ORDINANCE NO. 091916E

AN ORDINANCE TO AMEND THE UNIFIED DEVELOPMENT ORDINANCE OF THE CITY OF FISHERS, HAMILTON COUNTY, INDIANA

Text Amendment

VERMILLION PUD TEXT AMENDMENT

ILLUSTRATIVE HOME ELEVATIONS AND PLOT PLAN

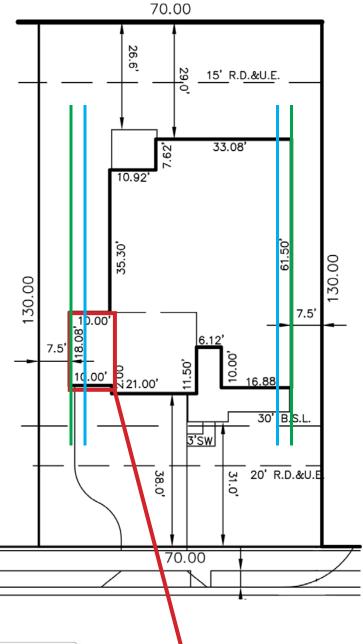
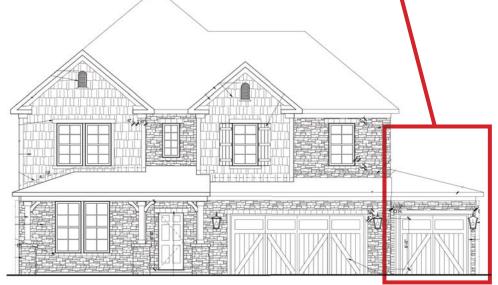
Area D Scenario

- Min. side yard (left):
 - 7.5' proposed (10' required)
- Min. side yard (right):
 - 7.5' proposed (10' required)
- Min. aggregate side yard:
 - 15' proposed (20' required)

The builder would like to offer homes that can accommodate an optional front-load third (3rd) car garage, as shown illustratively in red. The Ordinance's current side and aggregate side setback requirements, established in 2006, would not allow these homes to be constructed (the blue lines above show where the side setback lines would be under the current standard). The proposed amendment would update that standard to allow these homes to be built, and the updated standard would be similar to the City's standard currently found in the UDO (the solid green lines above show where the minimum side setback lines would be under the proposed standard).
